Addendum No. 1

Invitation To Tender ADM-23-04 George Street Parking Lot

This addendum is being provided in clarification to ITT ADM-23-04 released July 18, 2023

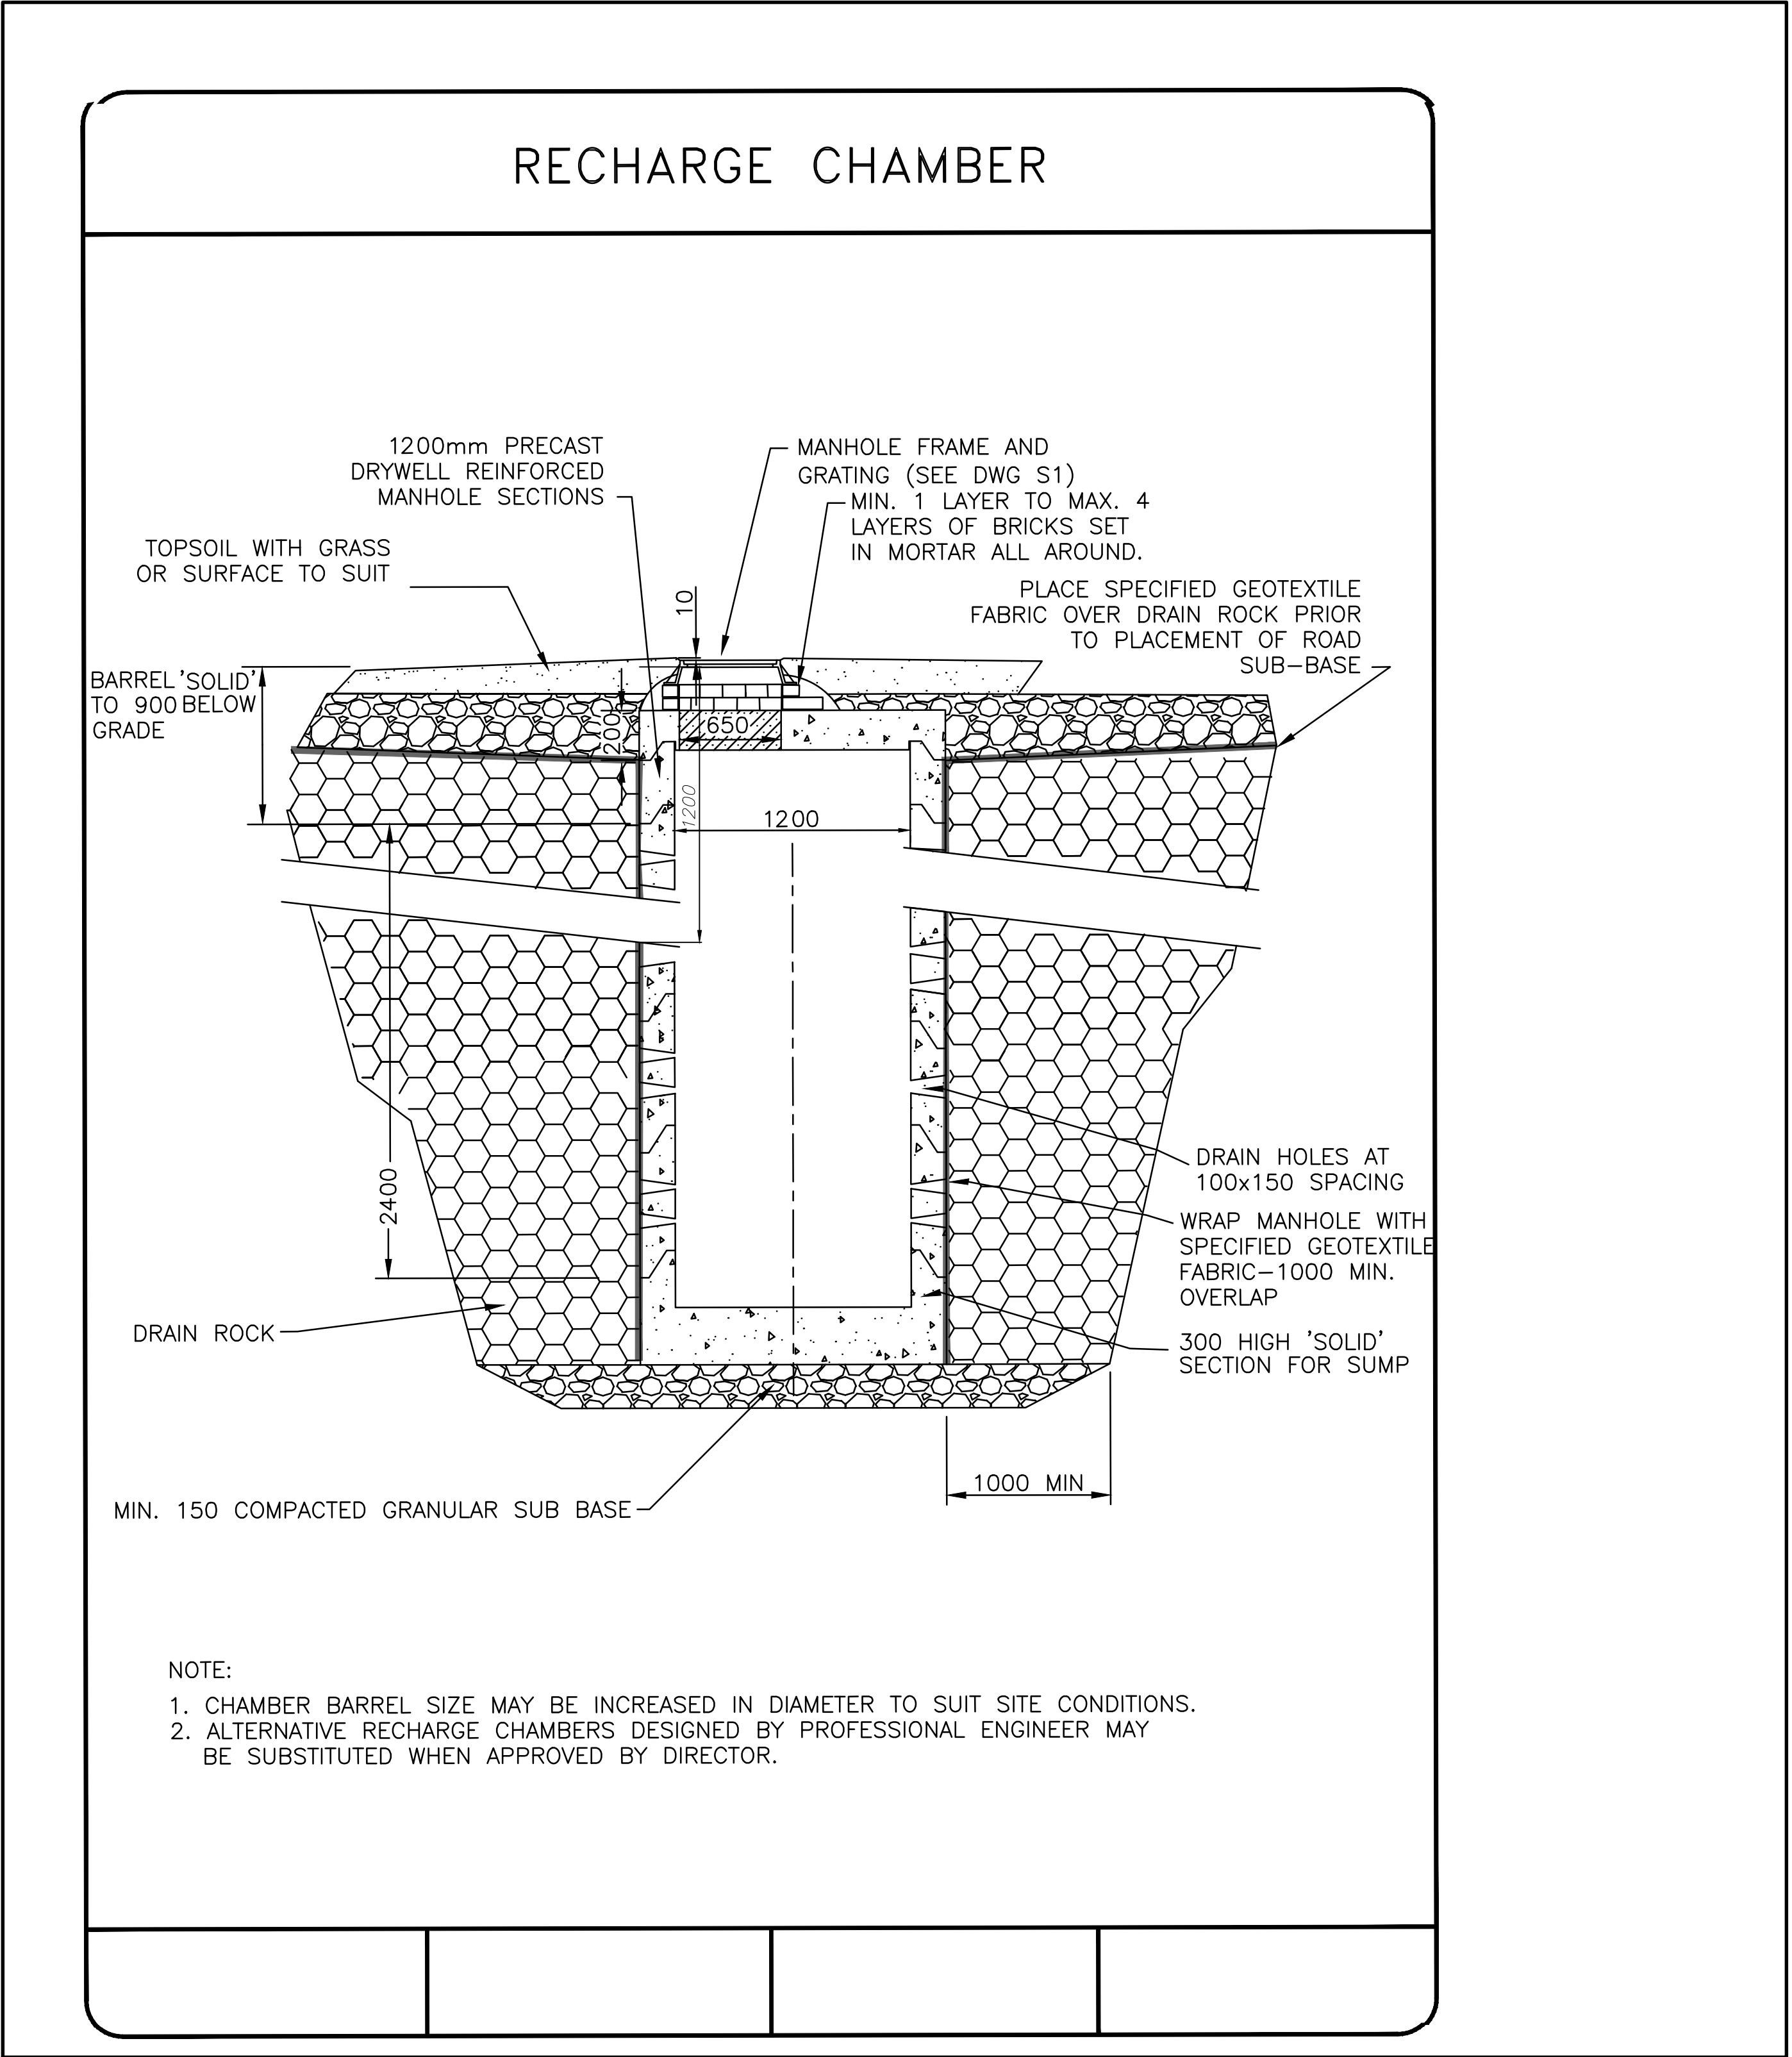
Question 6: Will there be a detail for the rock pit provided?

Answer: See attached modified detail for the rock pit, confirming use of 1200 mm diameter pre-cast, with a depth of 3.3 meters to the base of the pre-cast.
